Inspection Date(s):	05/20/25	
Media Program:	Water	
Regulatory Program(s)	Safe Drinking Water Act (SDWA)	
Company Name:	Tri-County Special Utility District – Public Water System	
Facility Name:	Tri-County Special Utility District	
Facility Physical Location:	5212 TX-7	
(city, state, zip code)	Marlin, TX 76661	
Mailing address:	P.O. Box 976	
(city, state, zip code)	Marlin, TX 76661	
County/Parish:	Falls County	
Facility Phone Number	(254) 803-3553	
Facility Contact:	Melissa Lloyd	Tri-County SUD Office Manager
	tricountysud@ctwa.com	
FRS Number:	110013278069	
System Classification:	Community Water System (CWS)	
PWS ID:	TX0730004	
Personnel participating in inspection:		
Janet Cherry	Eastern Research Group, Inc. (ERG)/ janet.cherry@erg.com	Lead Inspector
Maura Harbaugh	ERG/ maura.harbaugh@erg.com	Support Inspector
Melissa Lloyd	Tri-County SUD/ tricountysud@ctwa.com	Office Manager
Tim O'Neil	Tri-County SUD/ trstc@msn.com	President Board of Directors

Section I – INTRODUCTION

Section III – OBSERVATIONS

Photograph 7. 05/20/2025 02:03 P1010525.JPG

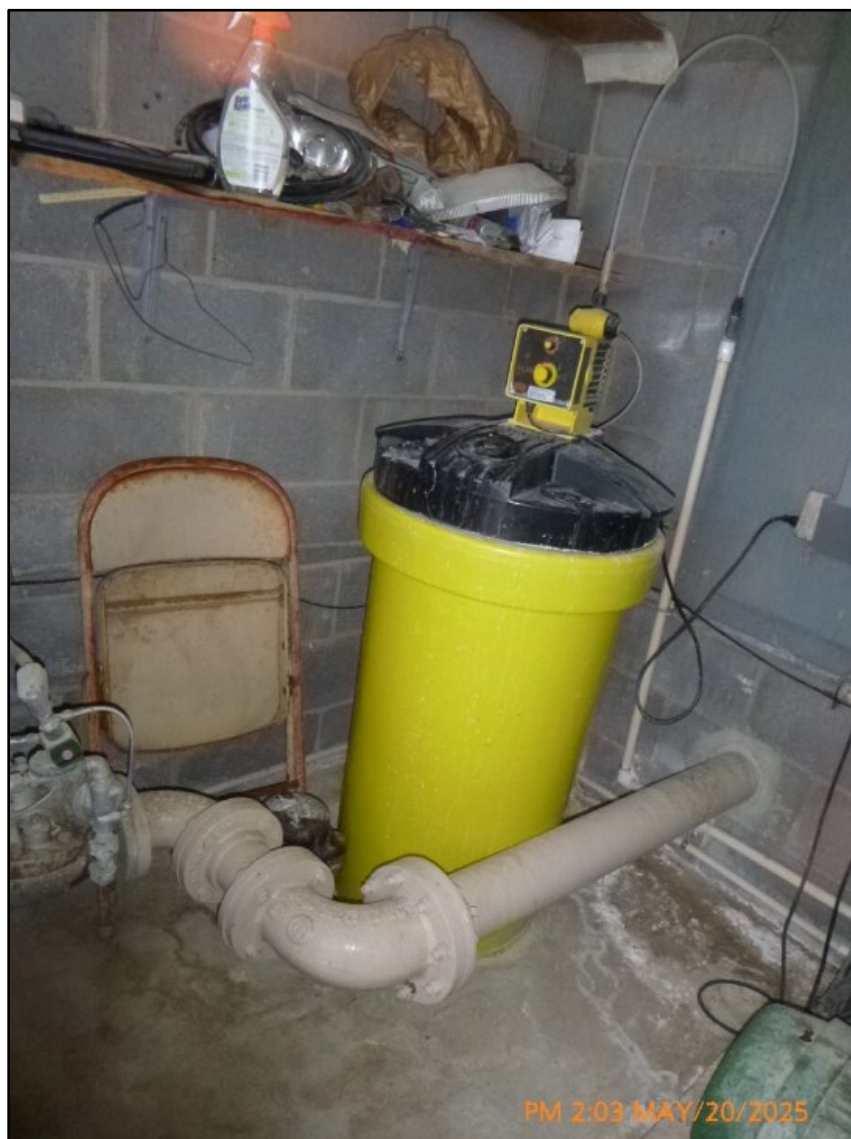
Observation 7. The Plant 6 polyphosphate chemical feed barrel did not have secondary containment (Refer to [Appendix 3, Photograph 7](#)).

Description: Containment provided for polyphosphate feed barrel at Plant 6 (Observation 7). Photo received June 24, 2025.
